# Proposed changes to London Luton Airport Arrivals

## SAIP AD6 Supplement:

Stansted Airport SID climb performance evidence  
supporting technical changes to altitude restrictions  
enabling the raising of CAS base levels

Figure 10 Rwy 04 CLN4S and Rwy 22 CLN8R, to CLN5S and CLN9R (conventional)

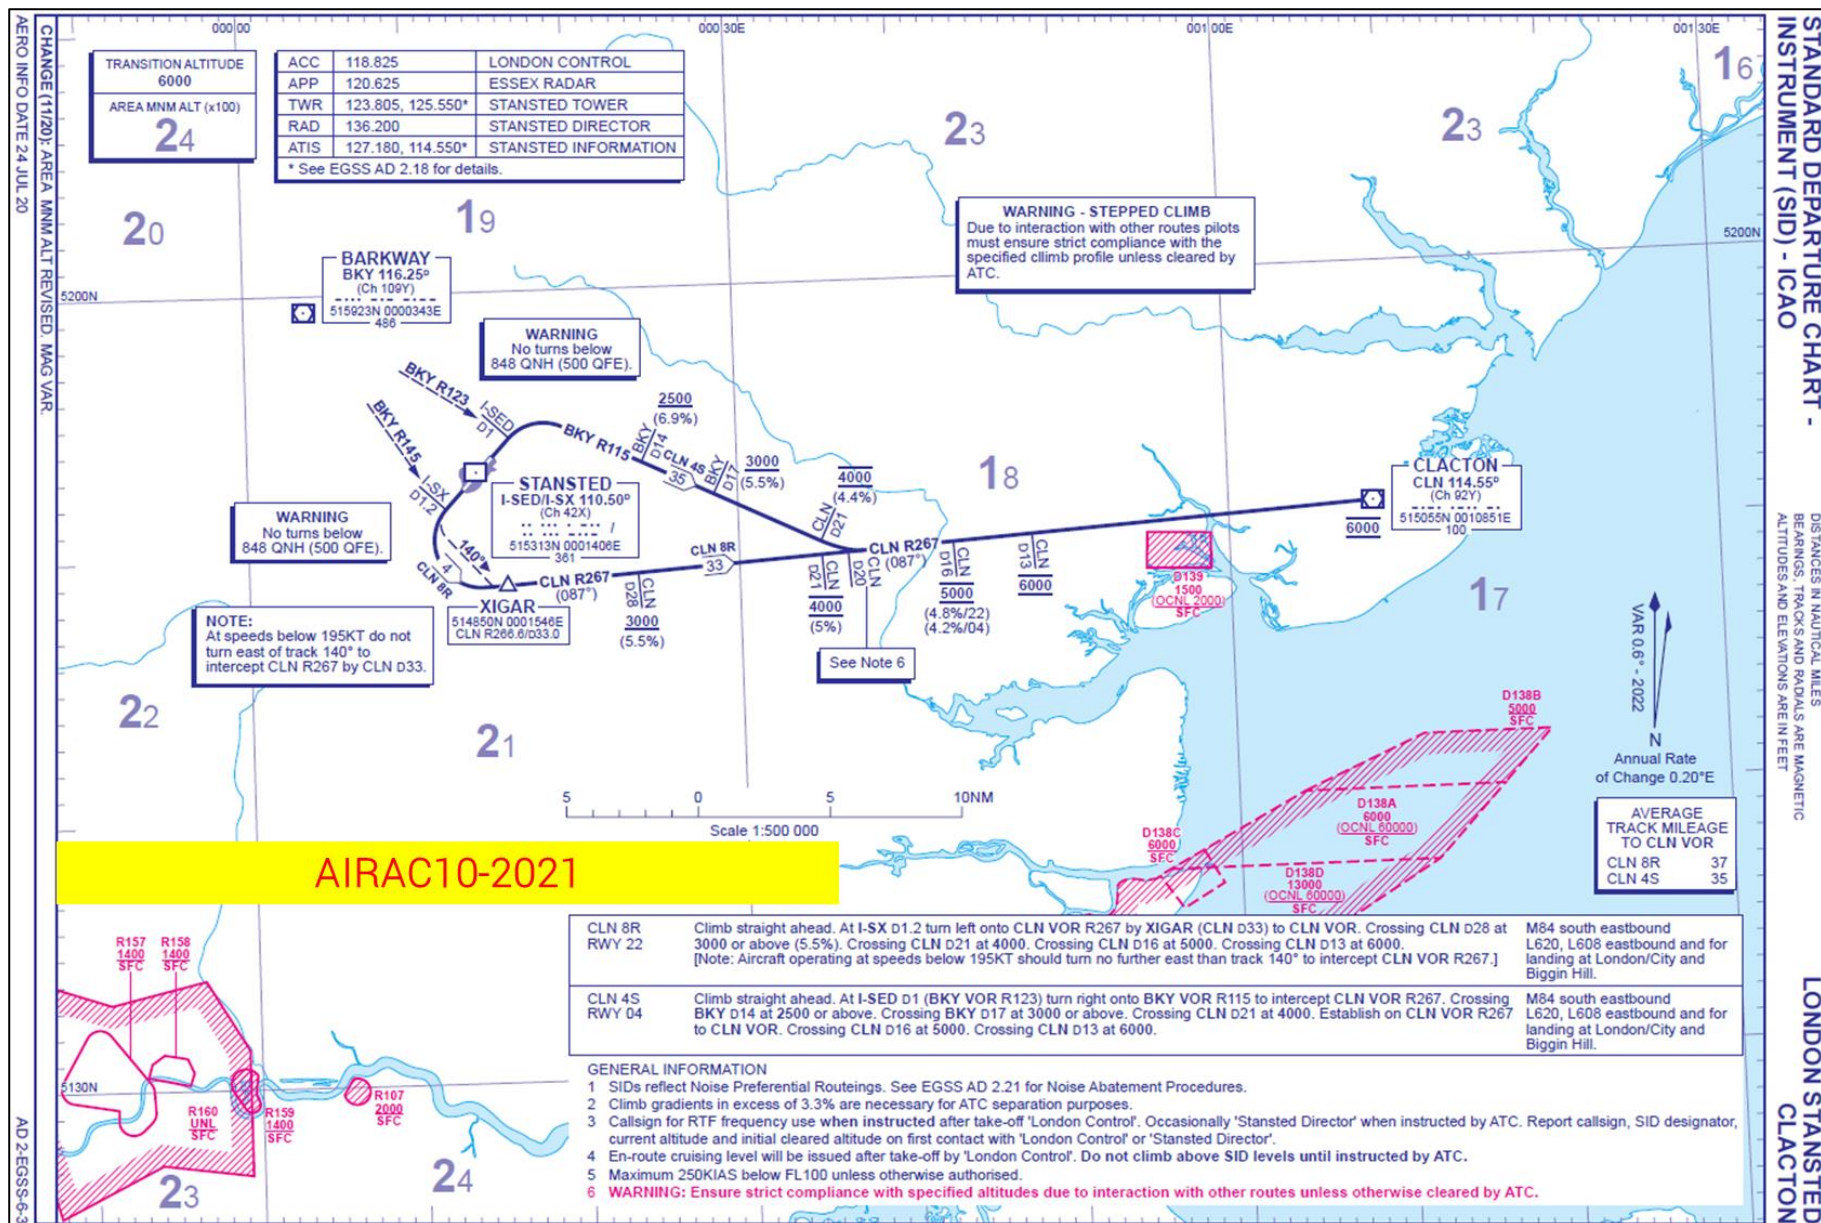
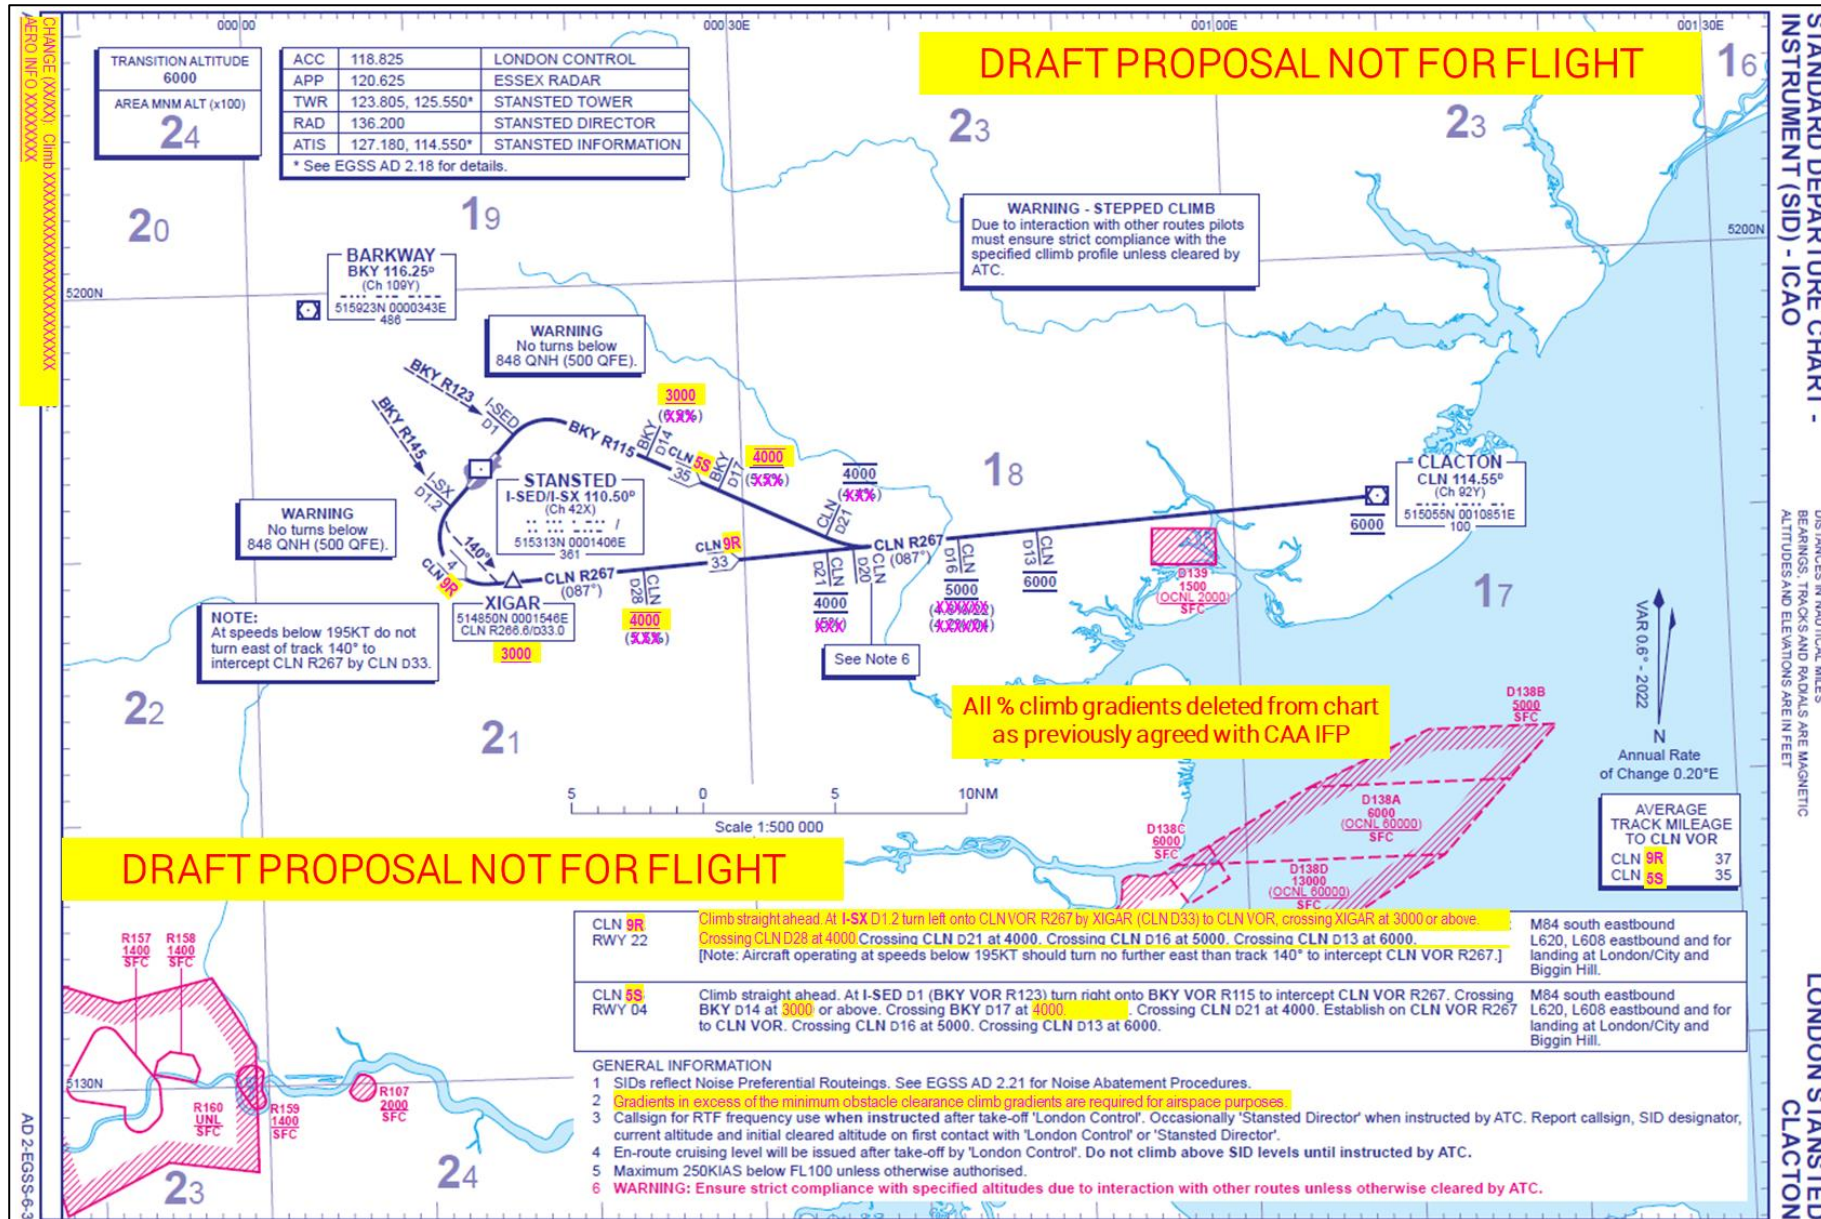
- 6.1 Rwy 04 CLN4S (conventional)
  - 6.1.1 Change altitude restriction at BKY R115D14 from 2500ft to 3000ft.
  - 6.1.2 Change altitude restriction at BKY R115D17 from 3000ft to 4000ft.

- 6.1.3 Up-issue the SID chart to CLN5S (see Figure 10 on p.21).
  - 6.1.4 As per the evidence supplied in paragraph 4.6 from p.8, aircraft already meet or exceed these proposed restrictions.

- 6.2 Rwy 22 CLN8R (conventional)
  - 6.2.1 Add an altitude restriction at XIGAR 3000ft.
  - 6.2.2 Change altitude restriction at CLN R267D28 from 3000ft to 4000ft.

- 6.2.3 Up-issue the SID chart to CLN9R (see Figure 10 on p.21).
  - 6.2.4 As per the evidence supplied in paragraph 4.7 from p.10, aircraft already meet or exceed these proposed restrictions.

Figure 12 Rwy 22 CLN1E, to CLN2E (RNP1) Chart

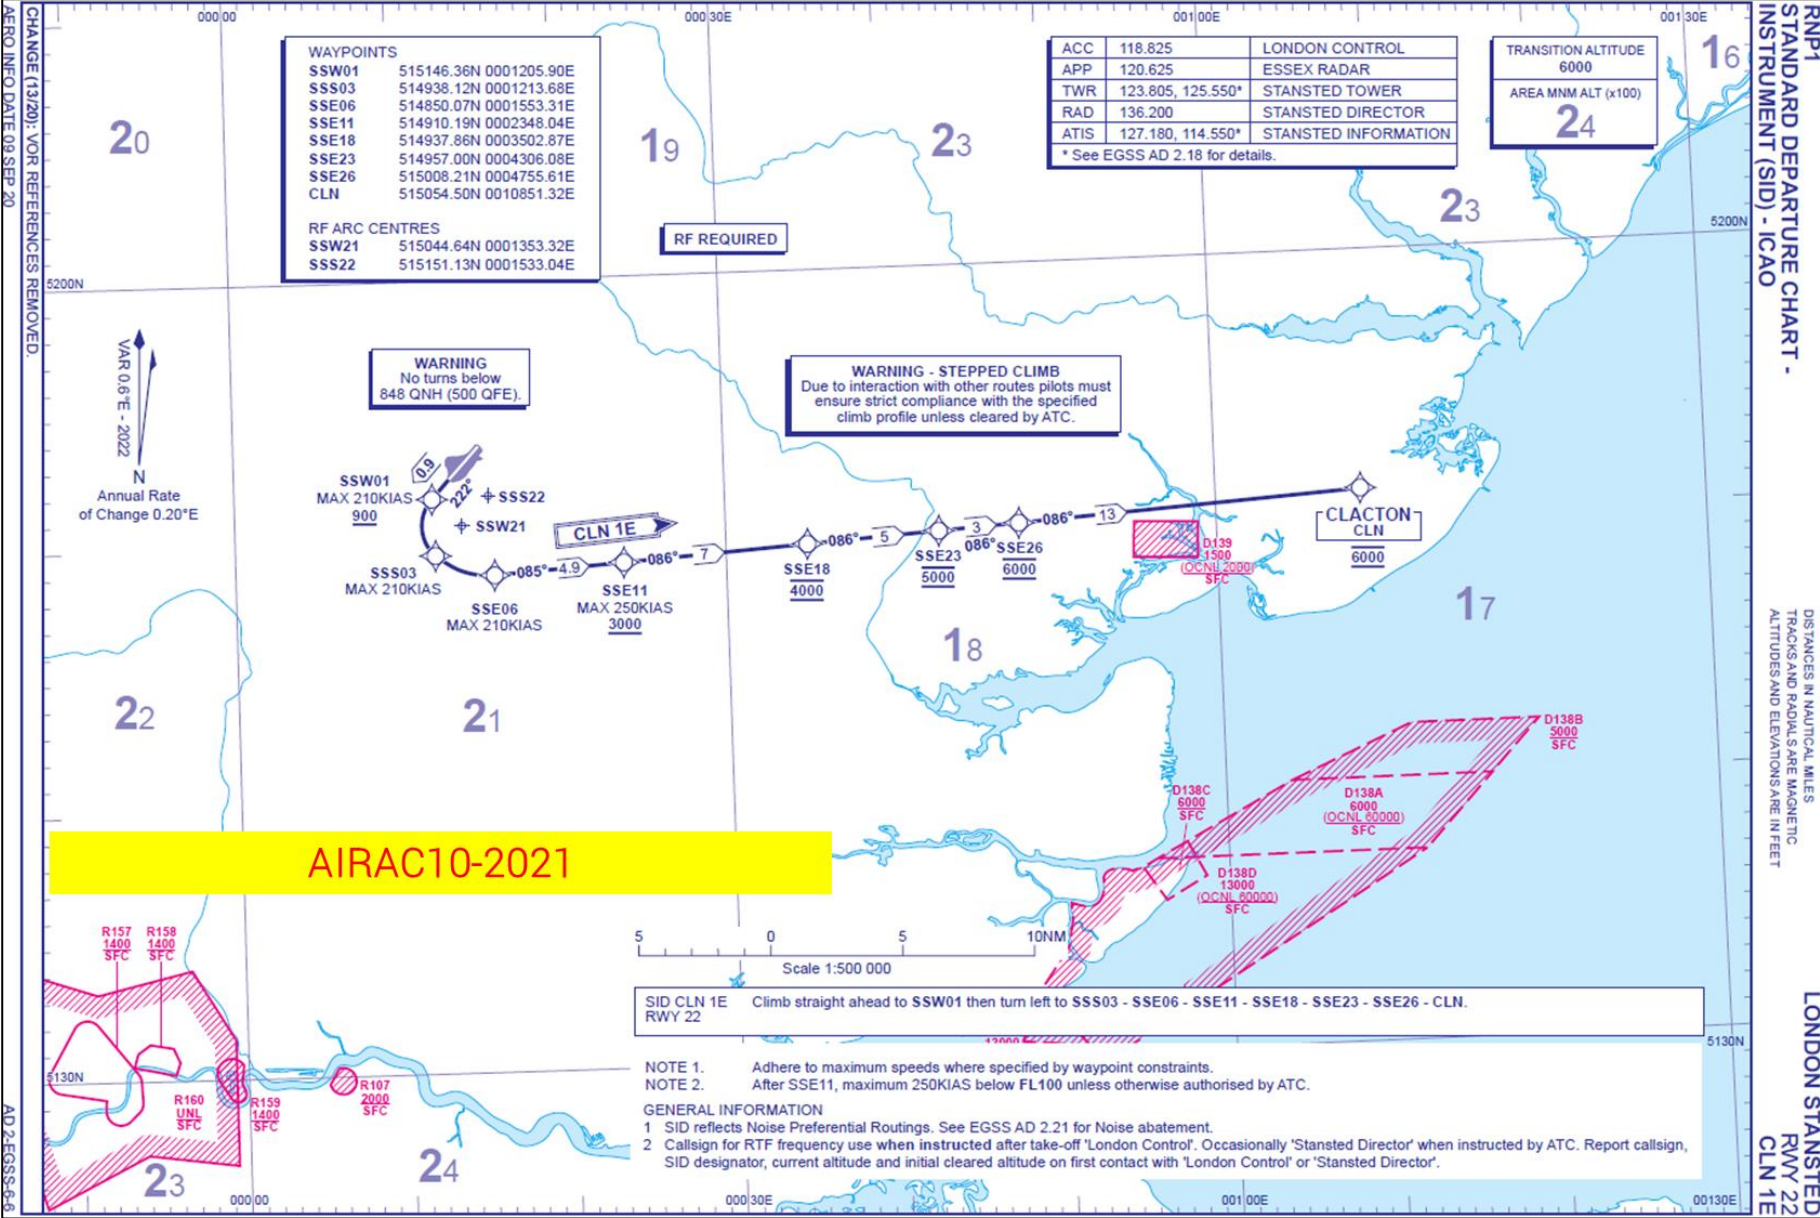
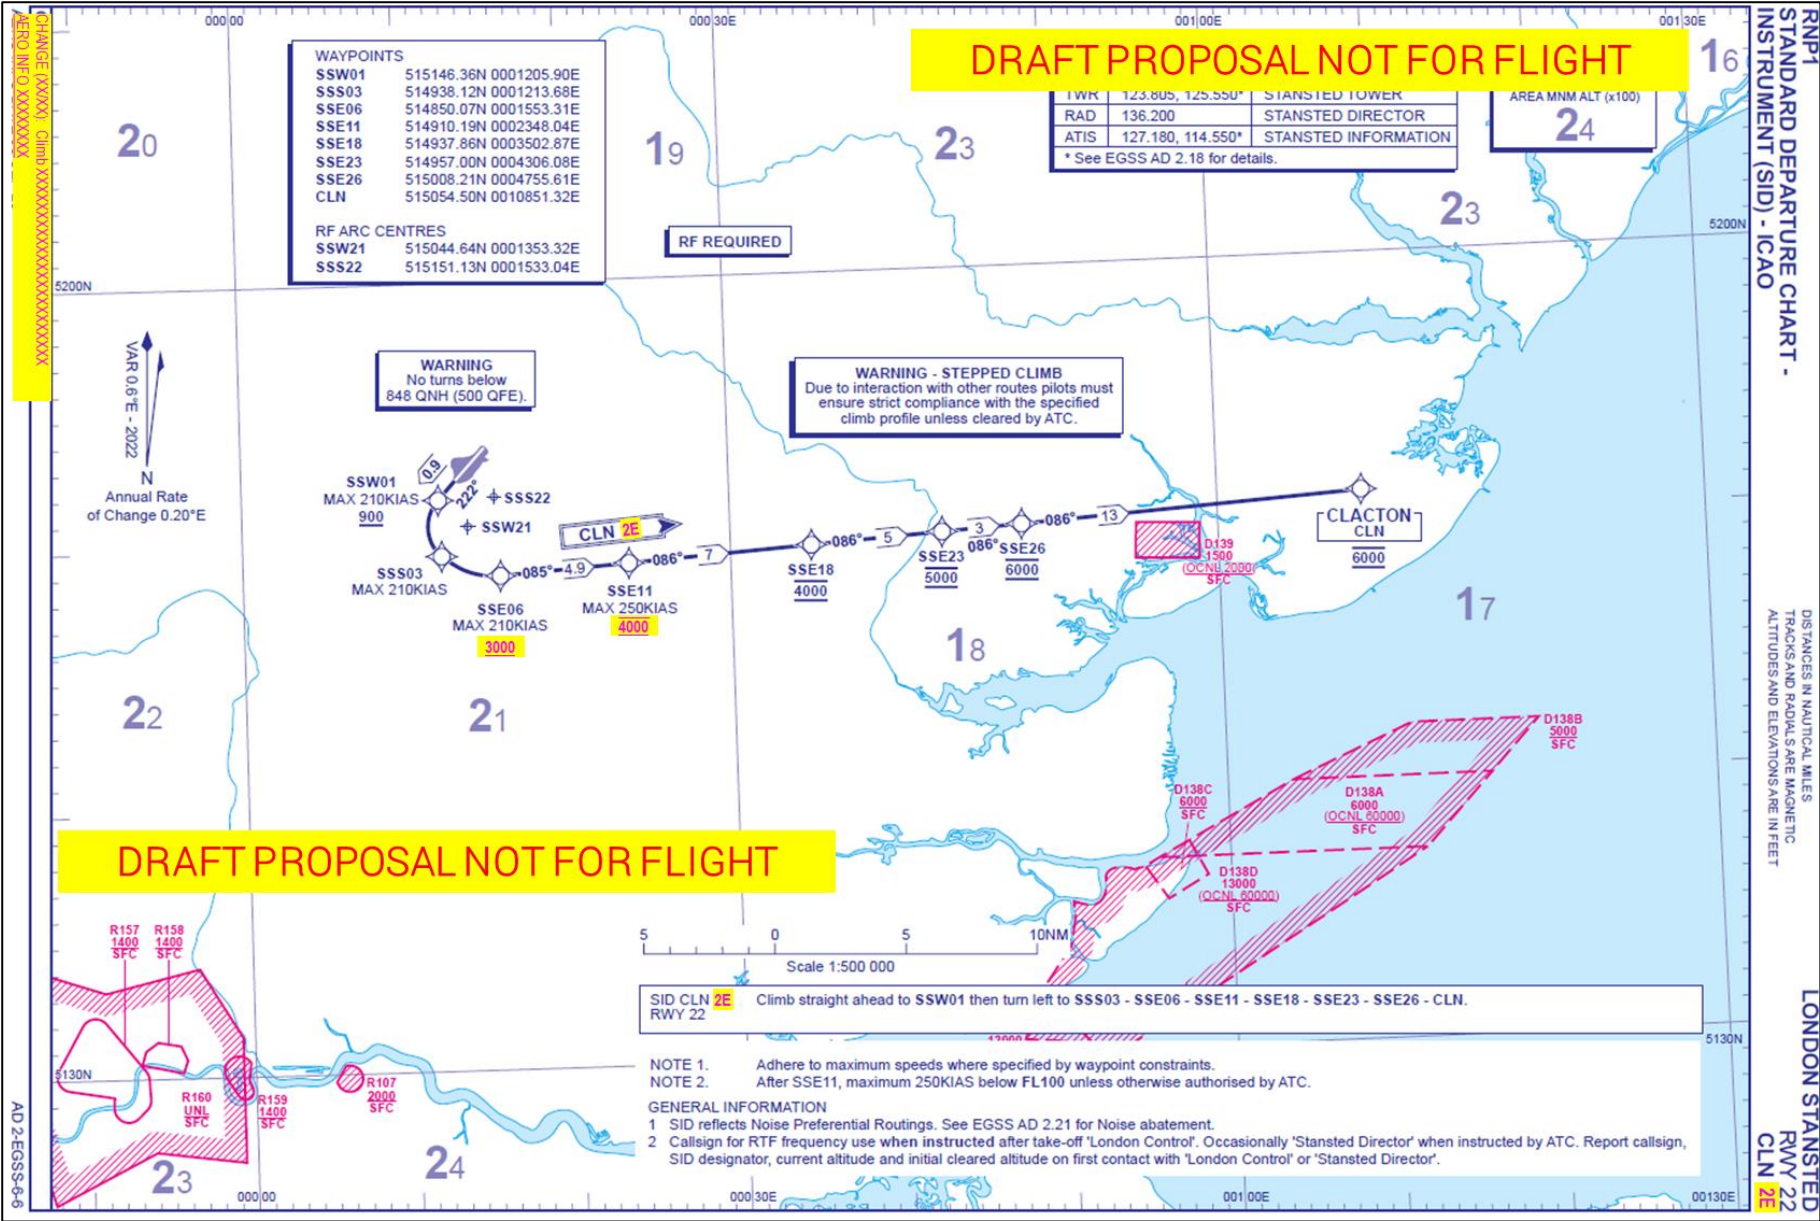
- 6.3 Rwy 22 CLN1E (RNP1)
  - 6.3.1 Add an altitude restriction at SSE06 3000ft
  - 6.3.2 Change altitude restriction at SSE11 from 3000ft to 4000ft
  - 6.3.3 Up-issue the SID chart and coding table to CLN2E (Figure 12 on p.23 and Figure 19 on p.30).
